Amendments to the Drawings:

The attached sheets of drawings include changes to Figures 28-32. Figures 28-31 have been amended to add a reference numeral 218 to indicate the bottom wall of slots 211.

Remarks/Argument

FIG. 31

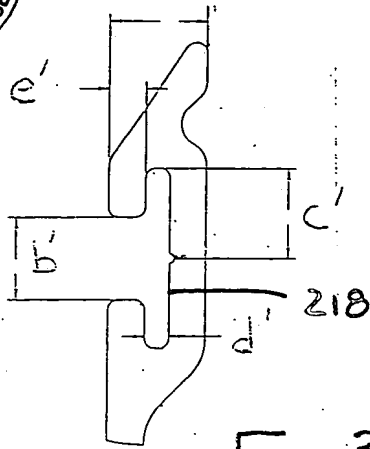
In the specification paragraphs [0095] and [0096] have been amended to provide a reference numeral for the bottom wall 218 of slots 211 of slot track 210. The drawings as filed and the claims as filed clearly show and recite a bottom wall. Figures 28, 29, 30 and 31 have been amended to add reference numeral 218. Applicants respectfully submit that the amendments to paragraph [0095] and [0096] and Figures 28 - 31 clarify the description of the slot track and the portion of the slot track referred to as the bottom wall. Applicants respectfully submit that no new matter is added, or intended to be added, to paragraphs [0095] and [0096] or Figures 28-31.

Claim 1 has been amended to clarify that adjacent slots 211, each having at least one undercut sidewall 214, form a slat 212 having a face with edges 213 defined by the slots. The bottom wall 218 is the bottom of the slot as shown in Figures 28-31 and is generally parallel to the face of slat 212. Applicants respectfully submit that while either adjacent or adjoining could be used to describe the relative position of two slots forming a slat, claim 1 has been amended to change adjoining to adjacent as proposed by the Examiner. Applicant respectfully submits that claim 1 as amended clearly describes the relationship of the elements of the slot track.
